**Peer Review Of “COMPUTATIONAL FLUID DYNAMICS  
(CFD) ANALYSIS OF ORIFICE PLATE METERING  
SITUATIONS UNDER ABNORMAL CONFIGURATIONS”,  
Version 2.0, Dr W. Malalasekera, May 2013**

Project No: KEE012

Report No:2013\_370

Date: August 2013

Figure 1 % difference in  $C$  for CFD and  $C_\epsilon$  for experiment from ISO 5167-2:2003

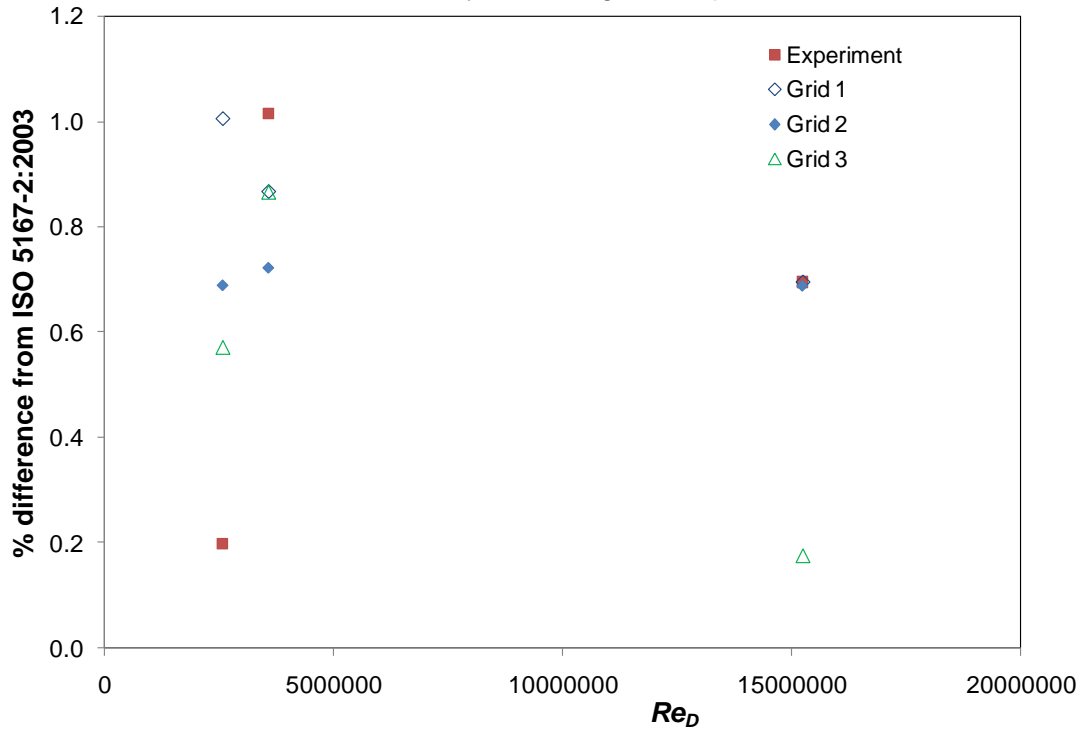
The differences between ISO 5167-2:2003 [4] and both the computed results and the experimental results are shown in Figure 1. These results are good in terms of agreement with experiment, especially given that the pipe is outside the roughness requirement for ISO

5167-2:2003, and the discharge coefficient at  $Re_D = 10^7$  would be expected from [5] to be 0.84 % above the standard. However, they still lack grid independence.

To establish whether the computations of flow through a standard orifice plate in [1] are grid-independent, axisymmetric computations could be performed and compared with the three-dimensional computations presented in [1].

Figure 2 Non-dimensionalised pressure profile through an orifice plate:  
NEL computation:  $Re_D = 10^7$

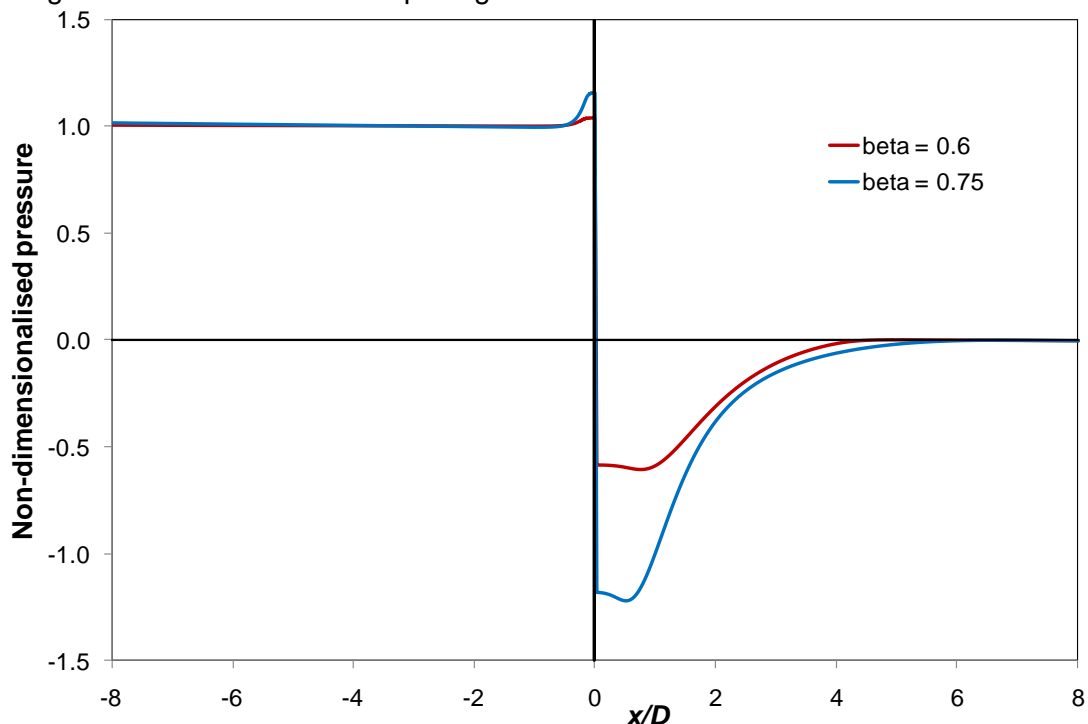
Nevertheless, it is interesting that the pressure distribution downstream of the orifice is different from that given by experiment or other computational work. Both the experiments and the computations of Morrison et al. [6, 7] show that the pressure is constant from  $6D$  downstream of the orifice, and NEL computations of the pressure recovery downstream of an orifice plate are shown in Figure 2, whereas Malalasekara [1] in Figures 13, 16 and 20 shows a continuing recovery after  $6D$  downstream of the orifice plate (there is also a surprising kink in the pressure distribution just downstream of the orifice plate in Figure 20). It appears that poor computation of the downstream recovery has little effect on the discharge coefficient. It seems surprising that a thermowell  $9D$  downstream would matter.

Figure 3 Data for test cases 99985: for the CFD  $C$  is plotted, for the experiments  $C_\varepsilon$

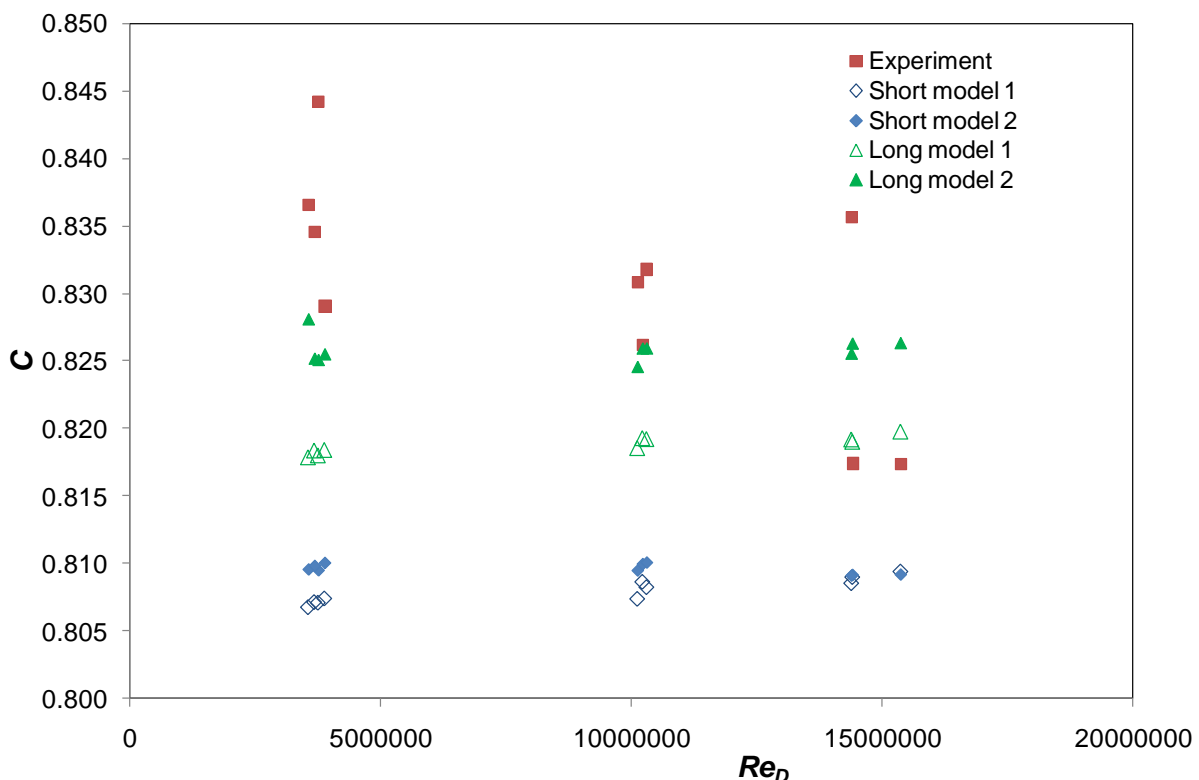
The CFD and the experimental data are plotted in Figure 3. Throughout the analysis here the orifice diameter has been used in the definition of discharge coefficient. It might be better to calculate a diameter based on the open area at the orifice, but the conclusions would be the same.

Both sets of CFD calculations show that there is very little effect of Reynolds number on the discharge coefficient. The variation in the experimental data with Reynolds number is largely due to higher uncertainty at lower differential pressure. The 'long model' calculations are not grid-independent: the two sets differ by about 0.8%. The 'short model' calculations are much closer to grid independence, differing by about 0.2% on average. NEL's expectation is that the difference between the 'long model' and the 'short model' calculations is due to lack of grid independence (especially for the 'long model') rather than to the fact that the downstream thermowell and bend are modelled in the 'long model'. For a correctly installed orifice plate Goldsmith et al. [8] showed that the effect of thermowells 1.63D to about 2D downstream on the measured flowrate was small, and that an oversized thermowell only 1.63D downstream of a plate had no effect at all. It would, therefore, be expected that a thermowell 9D downstream of an orifice plate would have no effect at all. ISO 5167-2:2003 requires 7.3D before a downstream bend; the bend here is 18D from the orifice; again it should have no effect at all. To demonstrate that the downstream effect captured in the long model is real it is necessary that the same grid be used until 8D downstream of the orifice plate and then two alternative downstream grids used and the discharge coefficients compared.

Considering the three experimental points for which  $Re_D$  is around  $1.5 \times 10^7$ , the highest of the points appears to have an error much larger than the stated uncertainty.

Figure 4 Data for test cases 99950: for the CFD  $C$  is plotted, for the experiments  $C_{\varepsilon}$

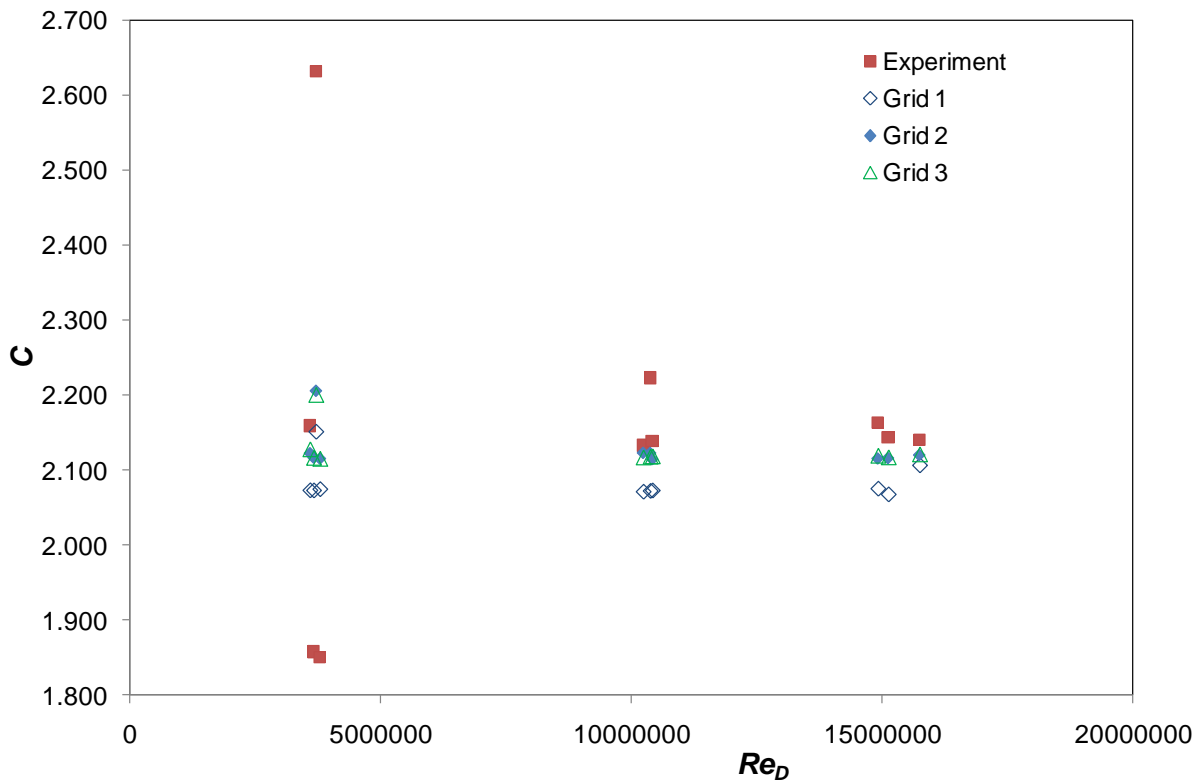
The CFD and the experimental data are plotted in Figure 4. Except for the first computation the computed values of discharge coefficient vary little with Reynolds number. The uncertainty of the experimental data is much higher than the values given in Table 12 of [1], where the uncertainty in measurements (presumably in differential pressure) is stated never to exceed 6 % (there are also errors in the calculated difference in error). Table 12 appears inconsistent with Figure 10. The discharge coefficients using Grid 2 and Grid 3 differ very little from each other; those using Grid 1 differ from the other two by a little over 2%.
